BULLETIN: BU-133 MC

MAIN BOOM ROCKER SHAFT FOR ROUND-UP RIDES MANUFACTURED BY FRANK HRUBETZ & CO., INC. AND KILINSKI MFG. CO.

MAN-CO MFG., INC. BULLETINS

30' ROUND-UP - SHAFTS AND SPINDLE REPLACEMENT

MAN-CO MFG. INC. 875 SW 45th AVE. S.E. GAINESVILLE, FLORIDA 32608	
SAFETY RING	INSTALLATION
DATE 2-17-72	
DRAWN BY BME	
SCALE	NO. RD-35-R

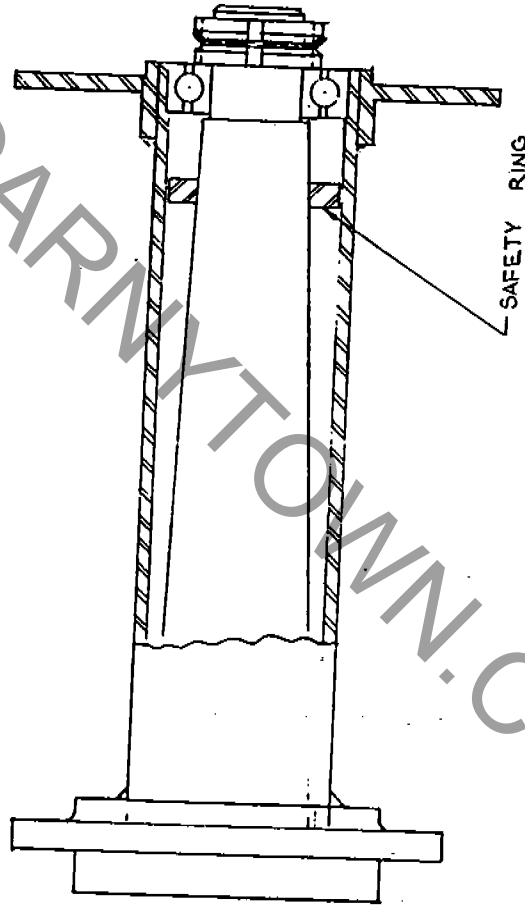
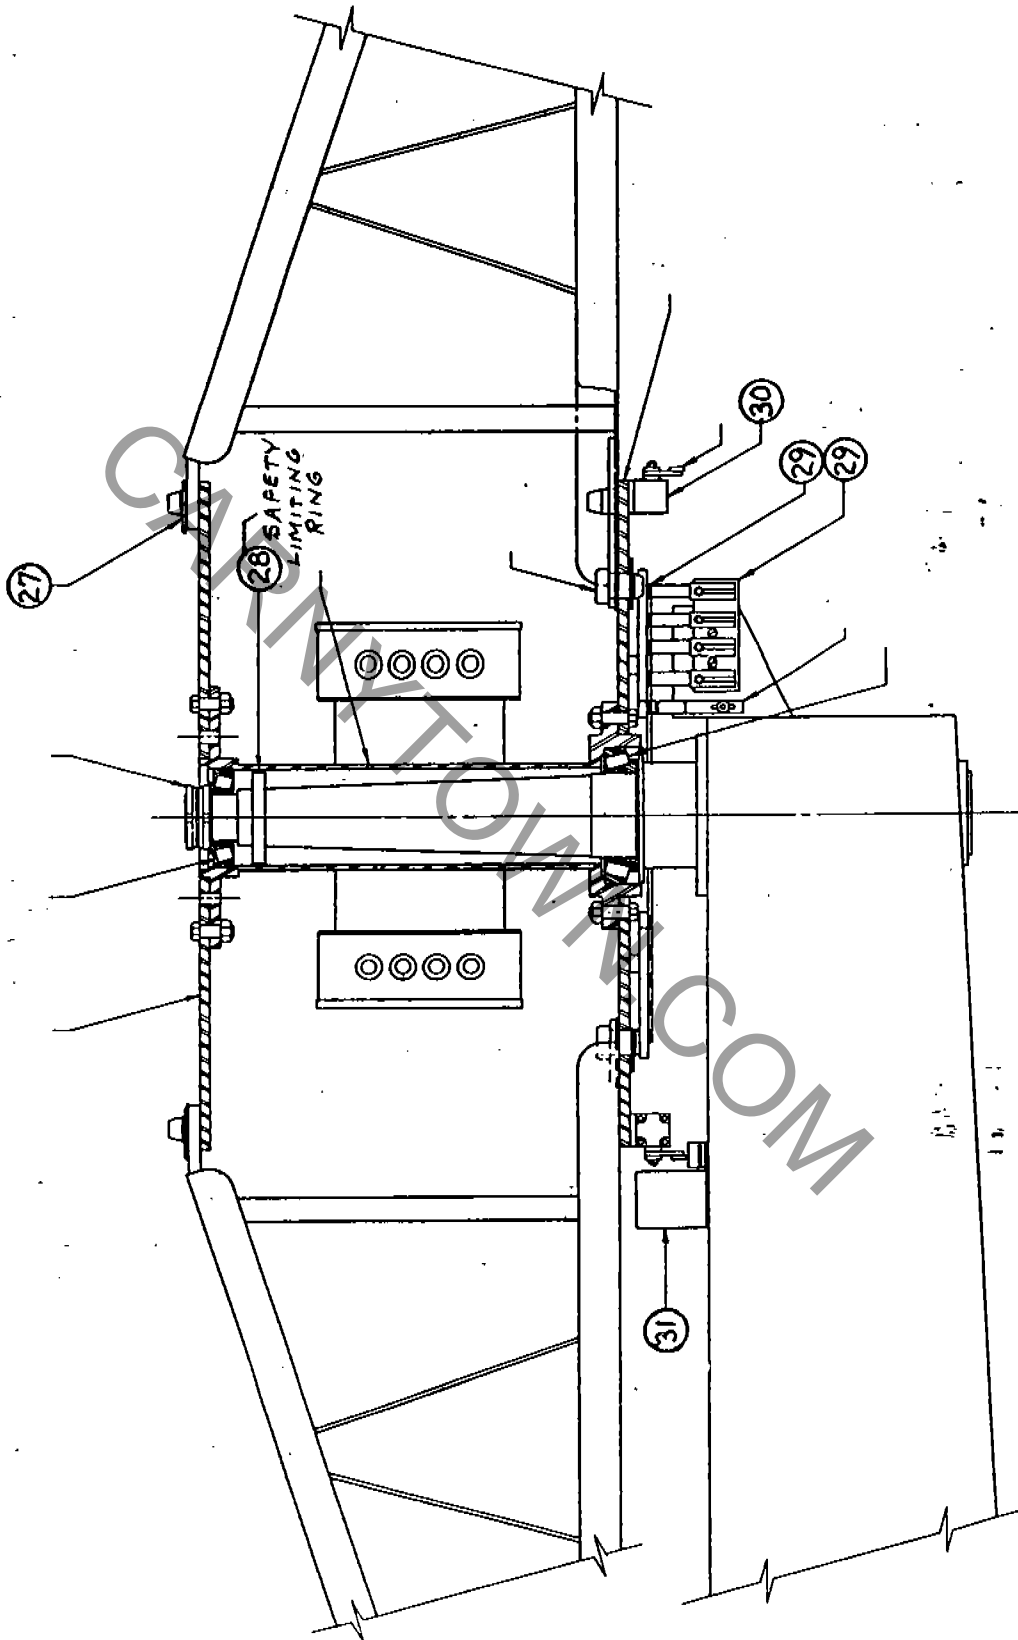
1. Remove the center ornament and inspect the weld on the hub (shown in drawings RD-35R and FR-503S) for cracks. If there are cracks, ship the hub to Man-Co Mfg.. We will repair, using the design presently being used.
2. Remove the top bearing and visually inspect the bearing and make sure there is a safety limiting ring in place. If there is a limiting ring on your ride, it will be plainly visible on the upper portion of your main spindle shaft. If it is not present, we highly recommend that you add this part immediately. (Part #STD 353)

BEFORE INSTALLING A NEW BALL BEARING ON A RIM DRIVE PARATROOPER MAIN SPINDLE, PUT A SAFETY RING ON THE SHAFT WITH THE TAPER CONFORMING WITH THE TAPER ON THE SHAFT. THE RING IS TO PREVENT THE HUB FROM COCKING TO ONE SIDE IF THE BEARING FAILS.

MAN-CO. MFG. INC.		P.O. BOX 12114 SALEM, OR 97309	
MAIU BOOM ROCKER SHAFT			
DATE	0-14-64	SHAFT DIMENSIONS PREVIOUS TO NO. SHAFKTS WITH SHRINK COLLARS	
DRAWN BY	M.O.Z.		
SCALE

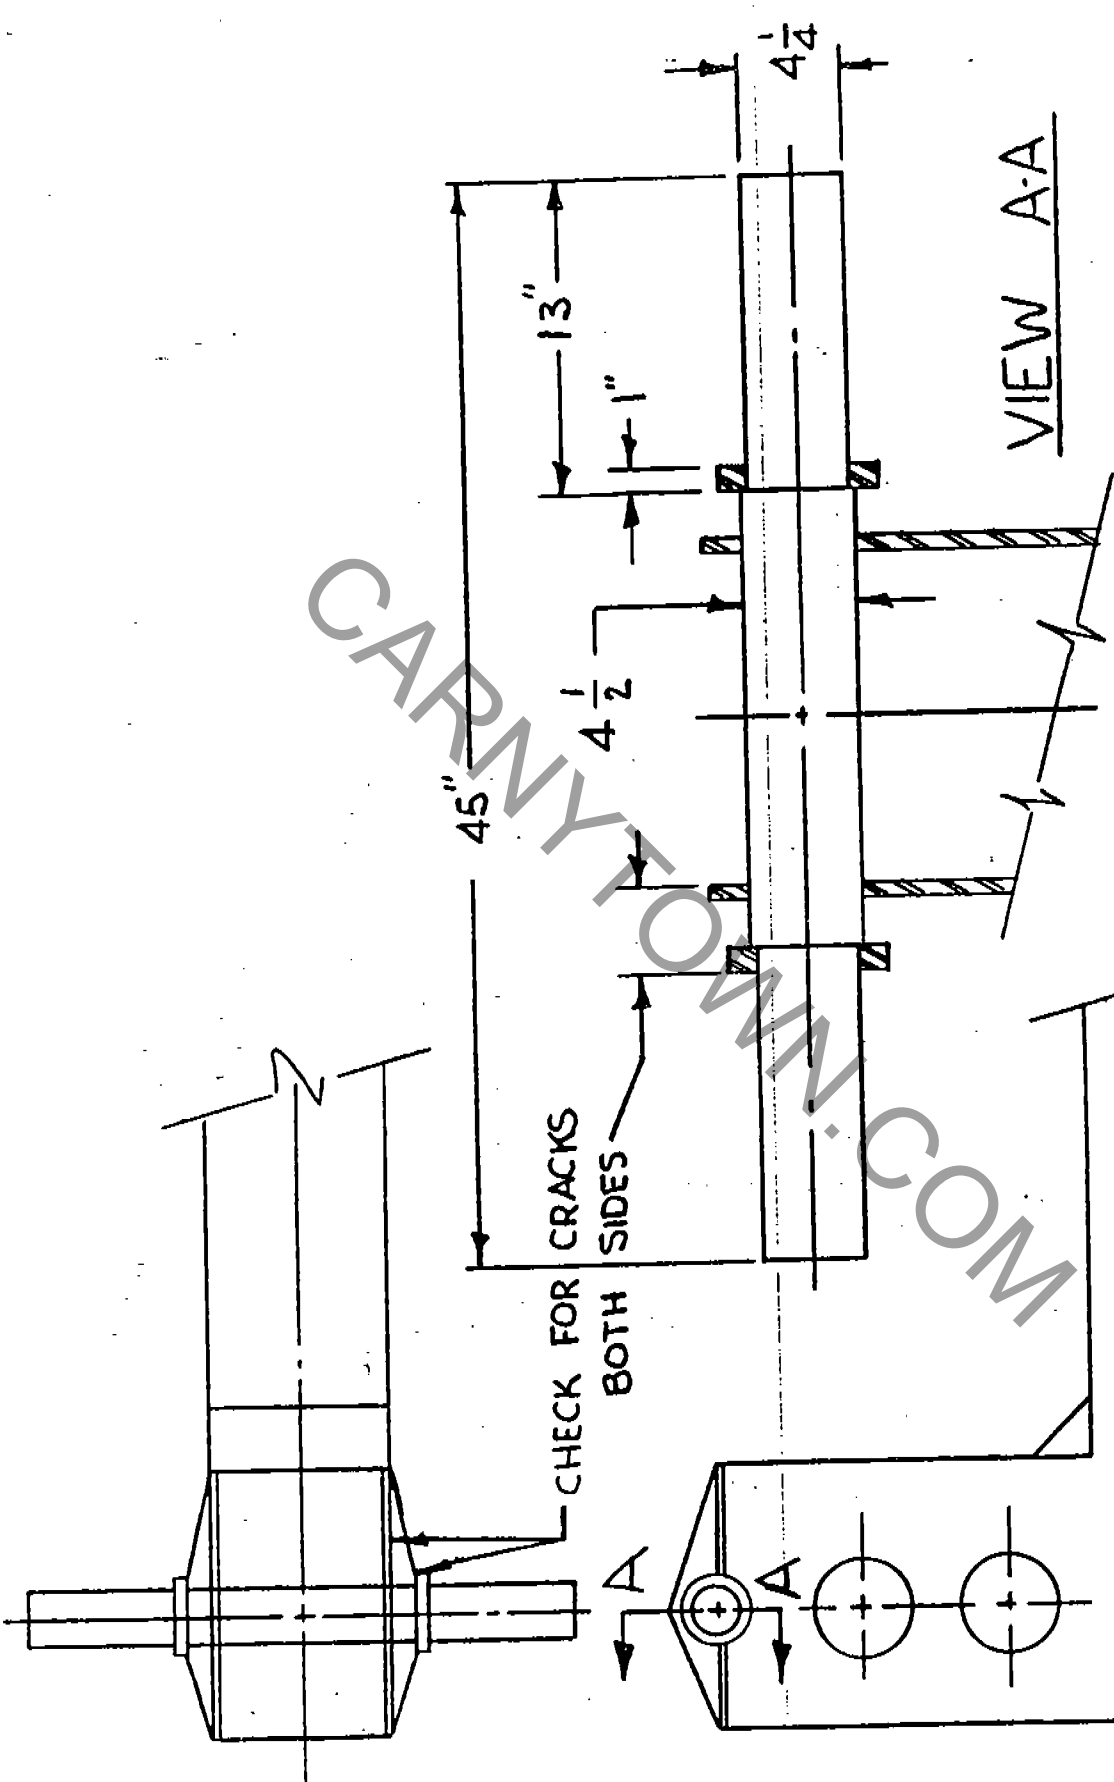
This test was performed on a Round-Up at Man-Co Mfg., Inc. by an independent testing lab, using a 2.25 MHz transducer on the end of the shaft. The instrumentation was set up to produce a strong reflection from the opposite end of the shaft and calibrated so that the shoulder on the far end of the shaft registered approximately 15-20% of full scale. This would cause a crack at or near the closer shoulder to register significantly. The test was repeated at the other end of the shaft. A sketch of the shaft is on Sheet 2.

MAN-CO. MFG. INC.		P.O. BOX 13114 SALEM, OR 97309	
CYL. ANCHOR SHAFT		SHAFT DIMENSIONS PREVIOUS TO SHAFTS WITH SHRINK COLLARS	
DATE	8-14-84	NO.	SHRINK COLLARS
DRAWN BY	M.O.Z		
SCALE

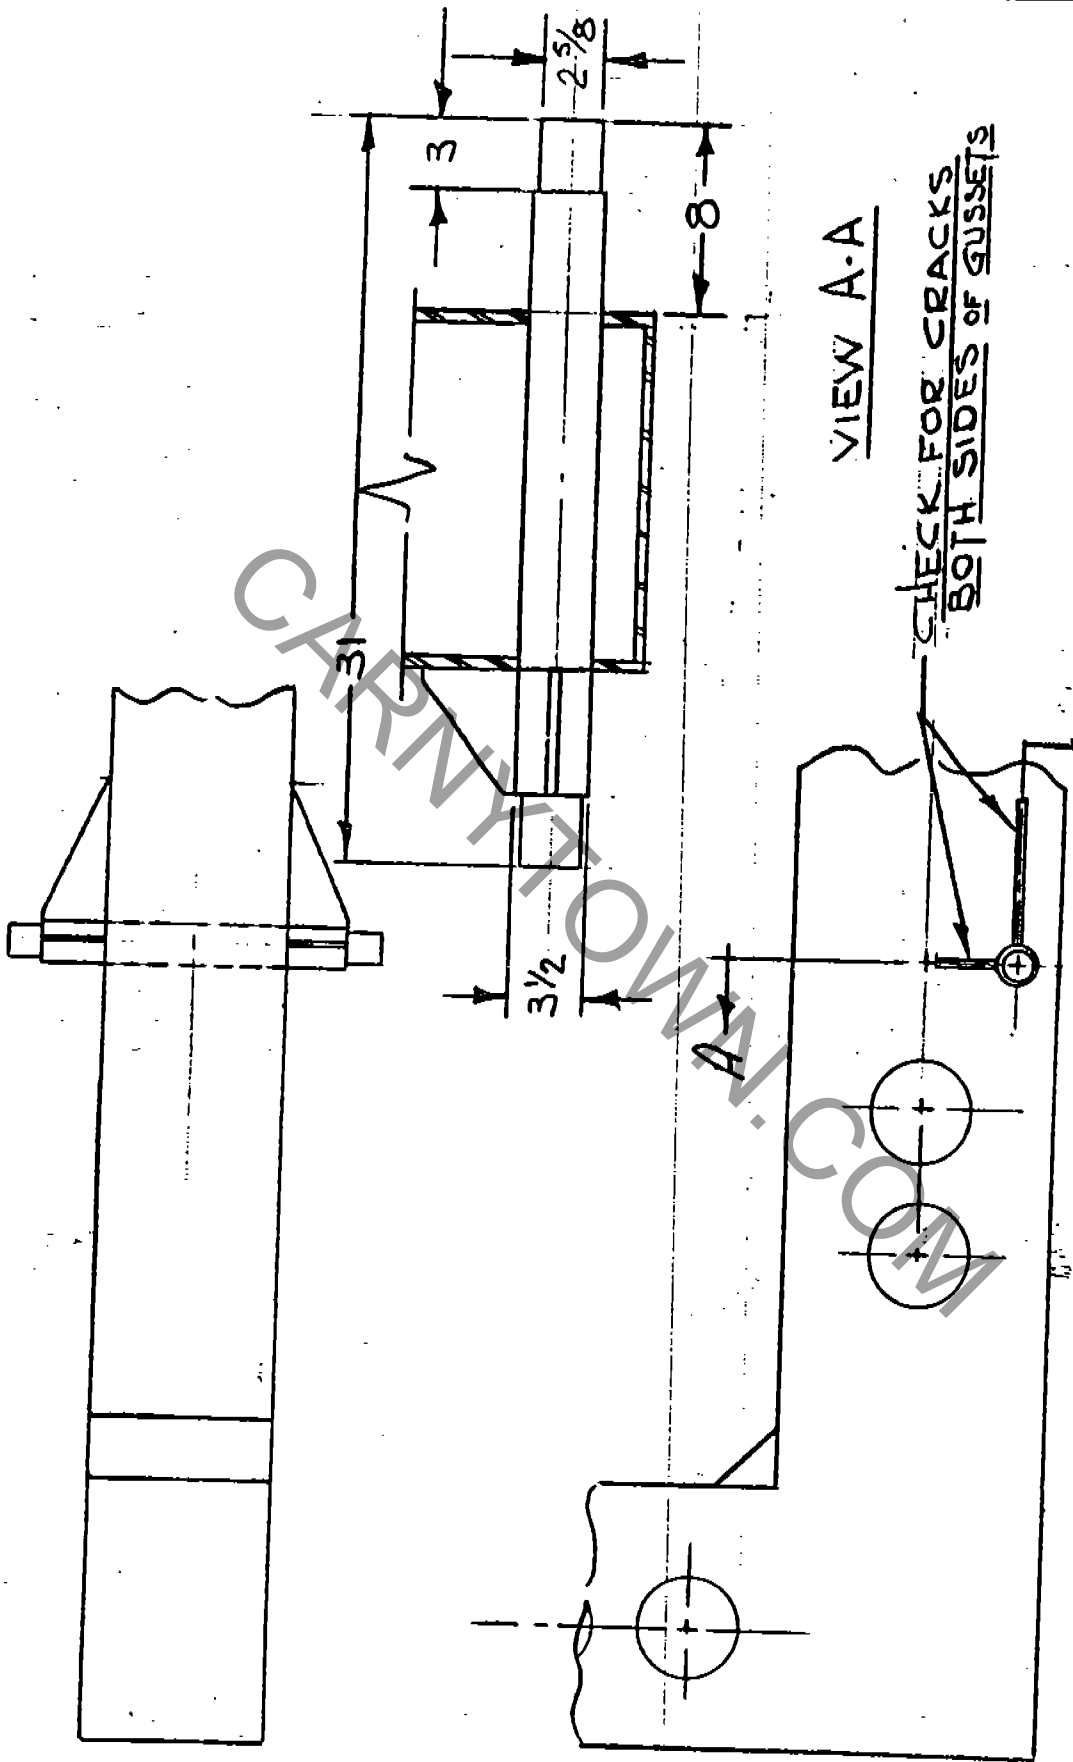
CHECK FOR CRACKS
BOTH SIDES OF GUSSETS

CENTER HUB - INSPECTION OF WELDS
 ROUND-UPS & PARATROOPERS

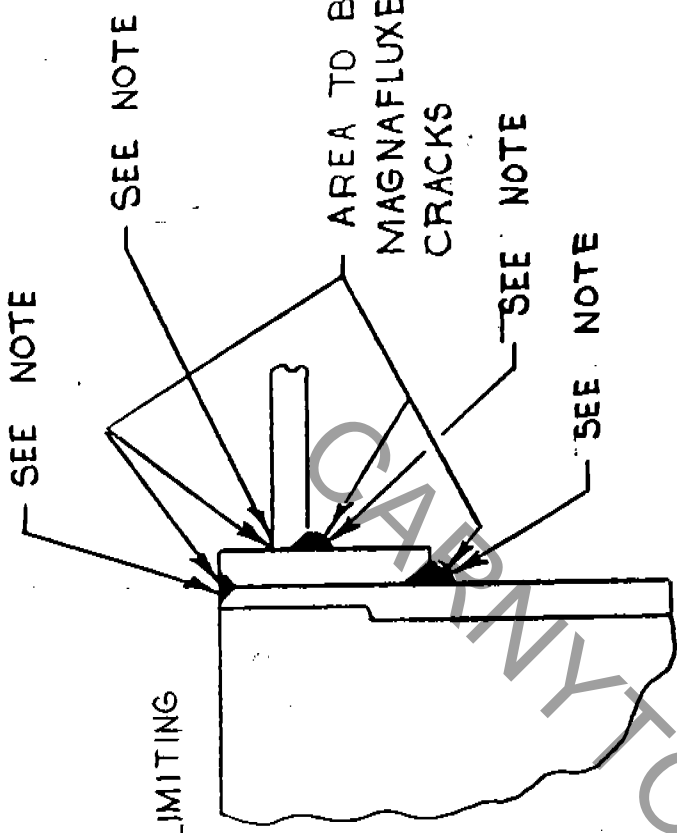
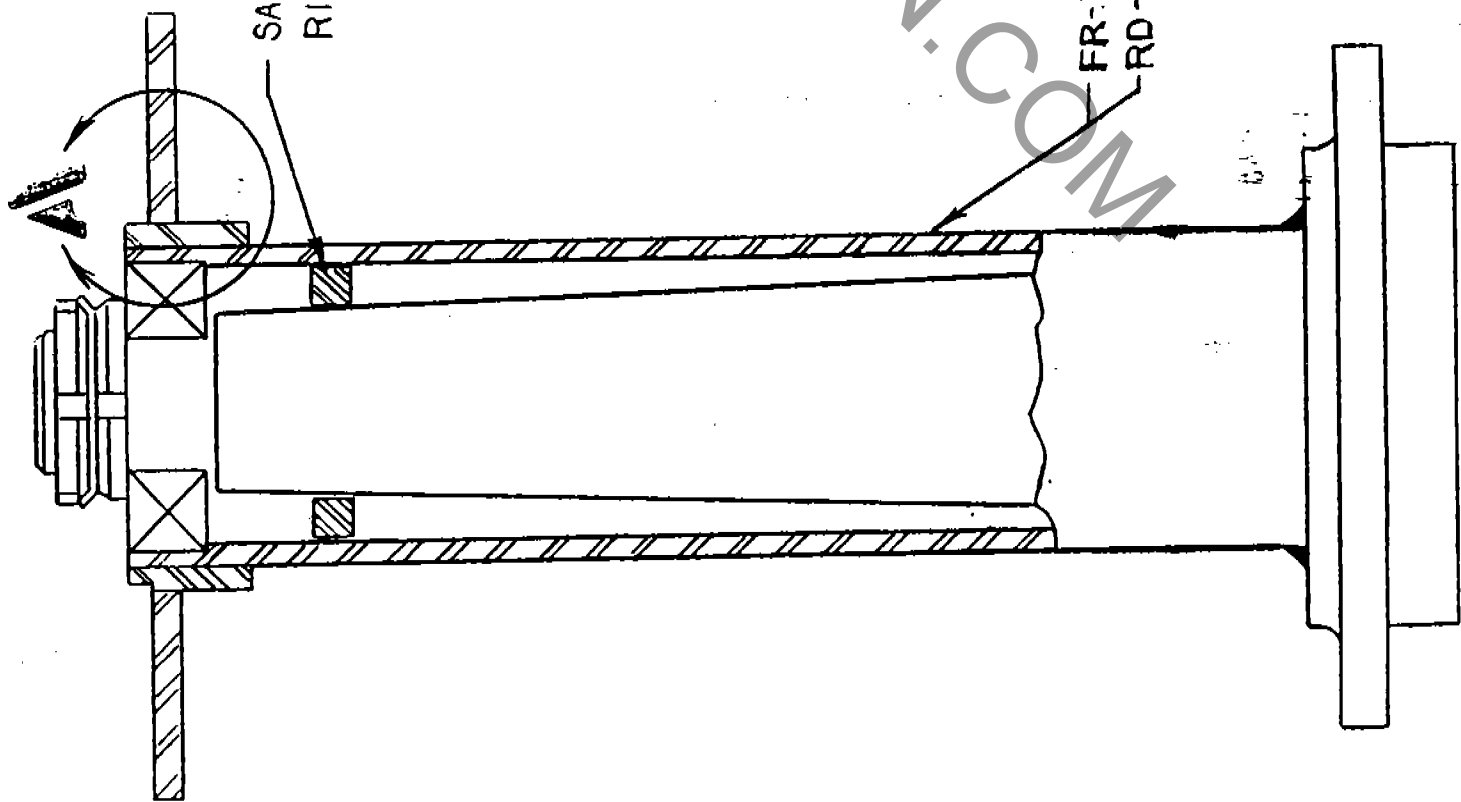
We at Man-Co feel that this is something that should be inspected on a more regular basis and so we are recommending that the welds shown in the attached drawing (BU-136-MC) be inspected annually. If any sign of stress or cracks are noted, then we recommend that the entire hub assembly be replaced for the safety of the ride owners and customers.

IF CRACK IS
NOTED IN THIS
AREA, CENTER HUB
SHOULD BE REPLACE

MAN-CO. MFG. INC.		P.O. BOX 18116 BALTIM, OR 97009	
SCALE:	DATE:	DRAWN BY:	
NONE	8-31-89	SWJ	
30' FOLDING ROUND-UP		ANCHOR SHAFT	
		B1 8-A

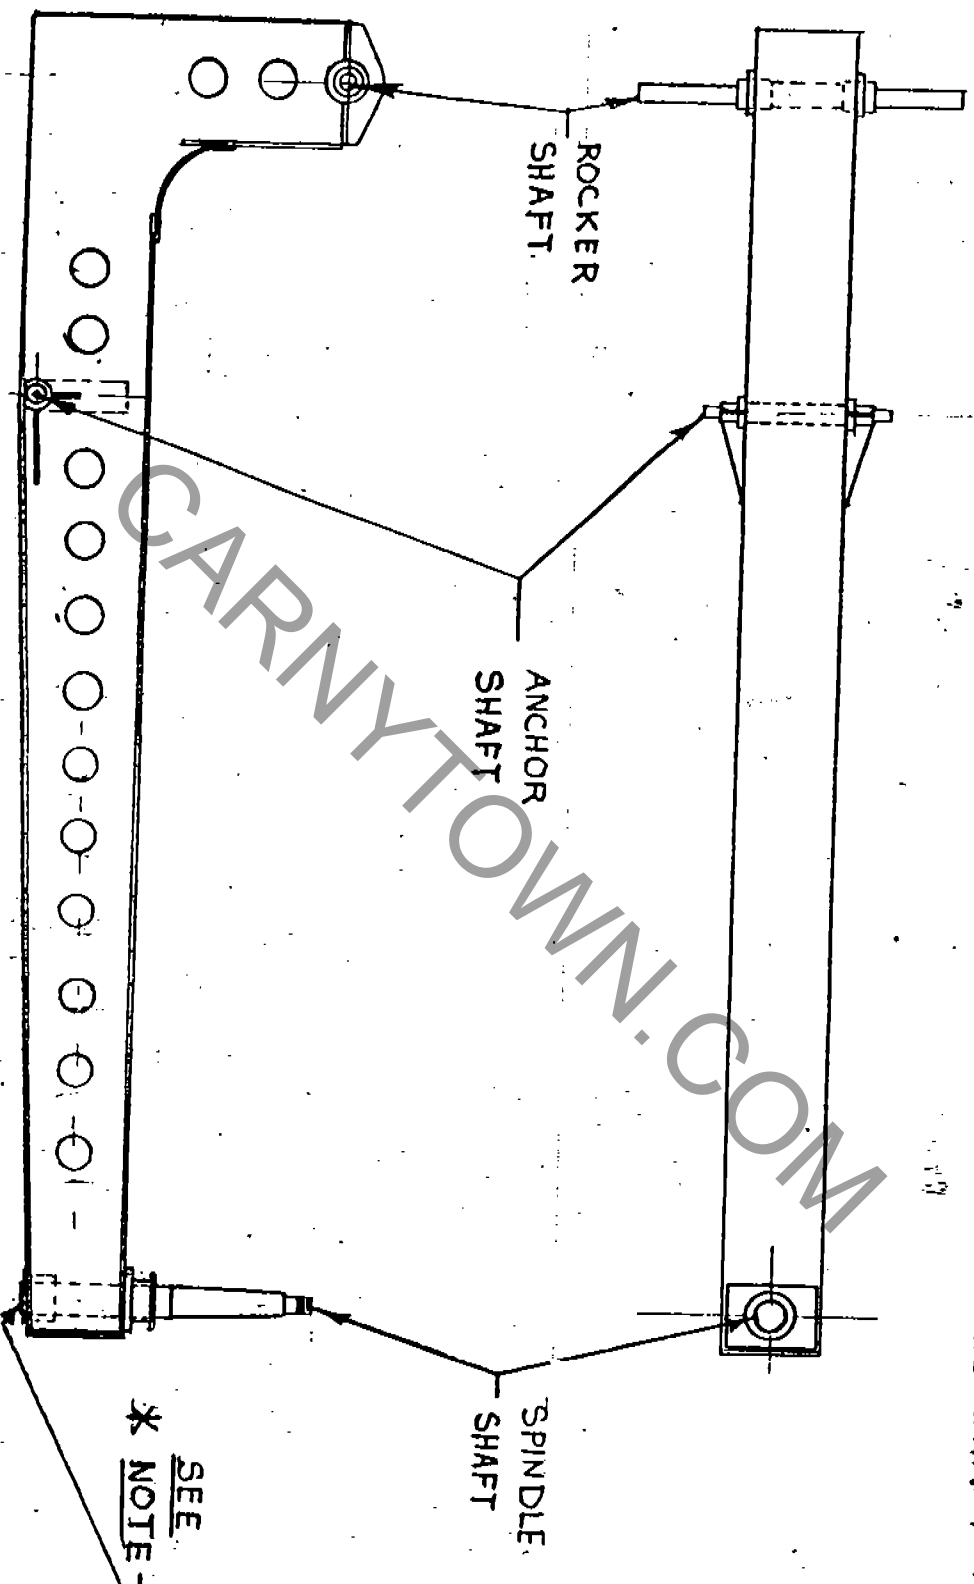
*NOTE: IF NO SHRINK COLLAR IS VISIBLE AT BOTTOM OF BOOM, THEN REPLACEMENT OF SPINDLE SHAFT IS NEEDED.
